PERMIT

SEWAGE DISPOSAL SYSTEM

HOWARD COUNTY HEALTH DEPARTMENT

SUBDIVISION Fulton Manor East LOT 8 ROAD 12309 Carol Drive

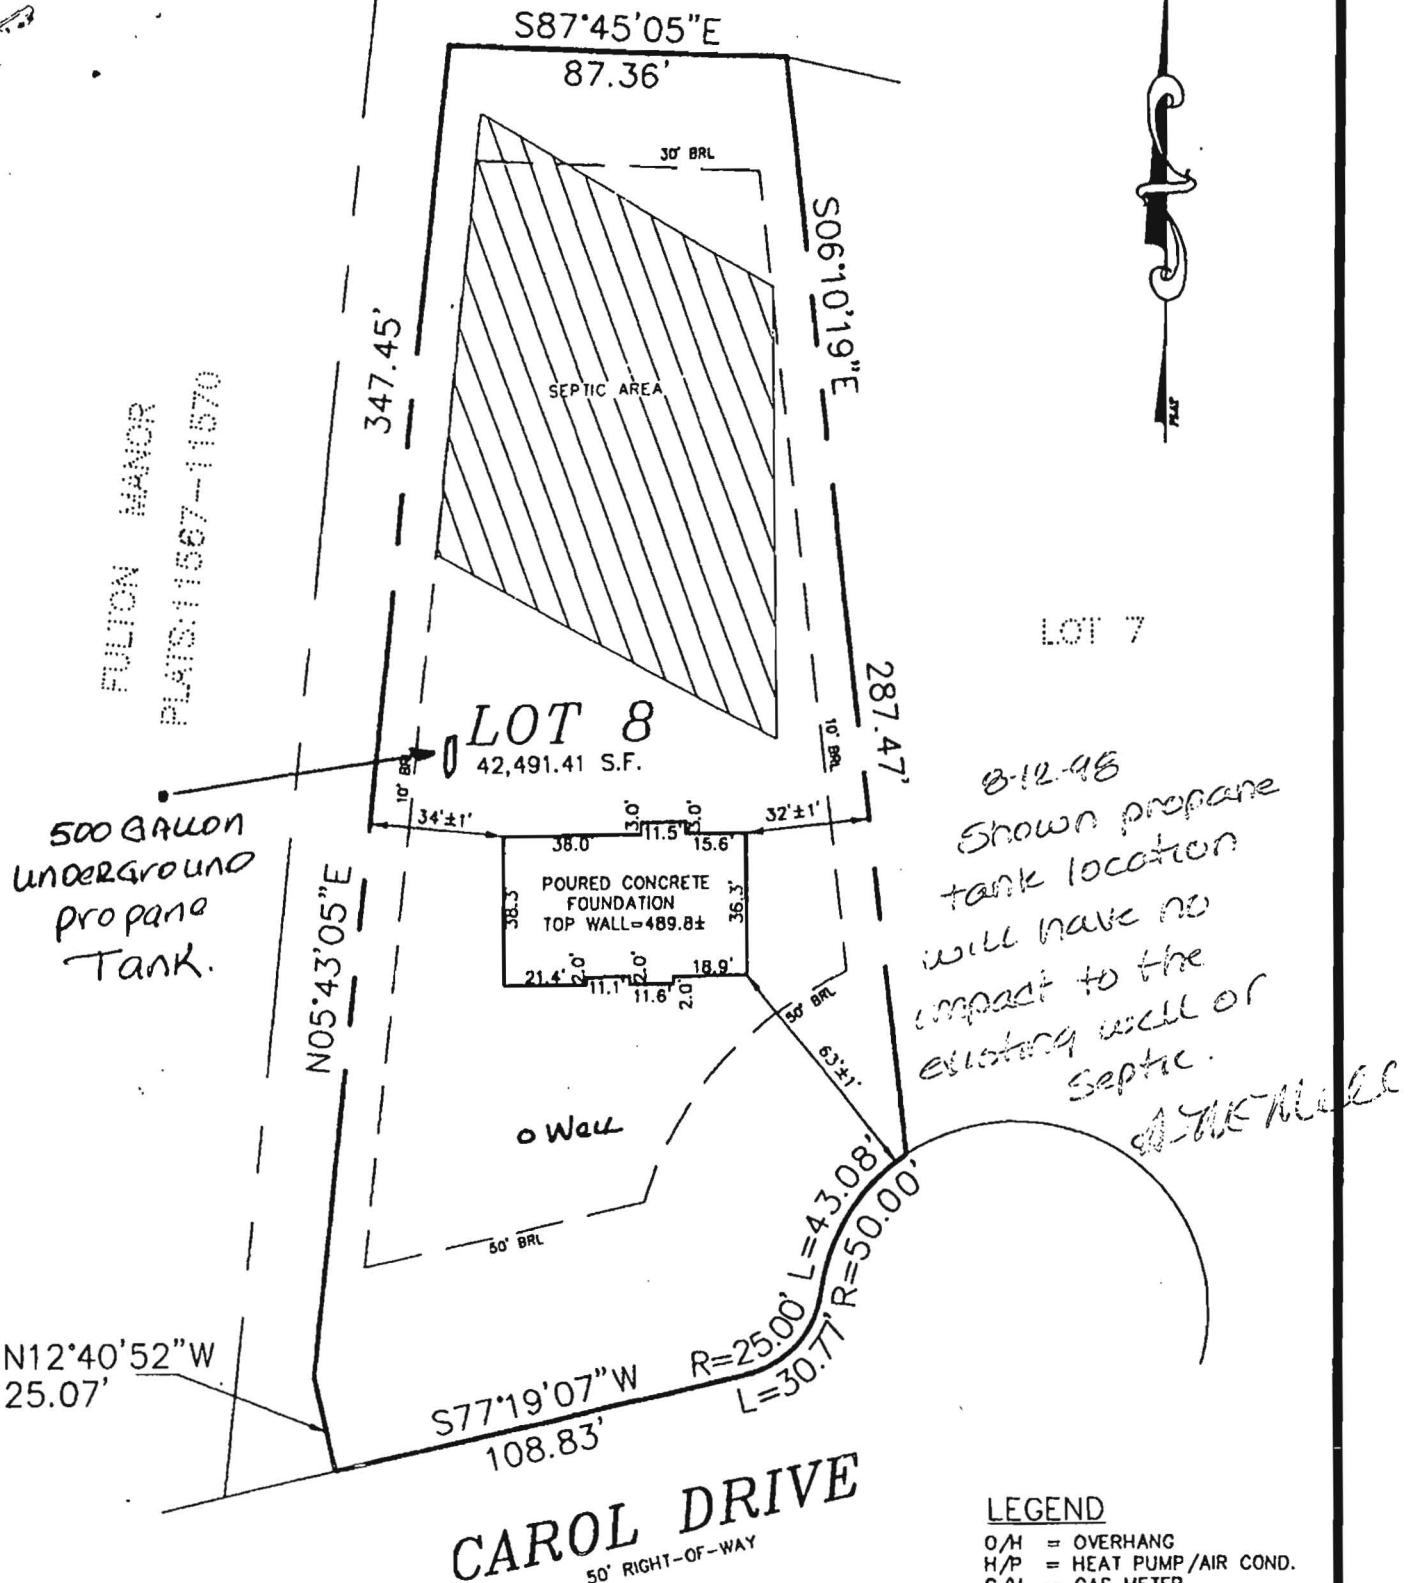
REMARKS: 7/16/98 HOUSE SEWER NOT EXITING HOUSE AS PER SITE PLAN, AND IS 4 1/2' LOWER THAN SITE PLAN. TOPD NOT PER SITE PLAN, BUT CONSISTENT W/ TRENCH DIRECTION. SHOWN; CONTRACTOR AGREES TO INSTALL 2ND TANK FOR FUTURE PUMPING. OK TO STONE TRENCH (1), DIG (2) 7/17/98 OK TO COVER TANKS, TRENCH (1) (MR) 7/17/98 OK TO FINISH & COVER (MR) w/PT. Poles & pipes & water line OK to cover R/P 5/22/98
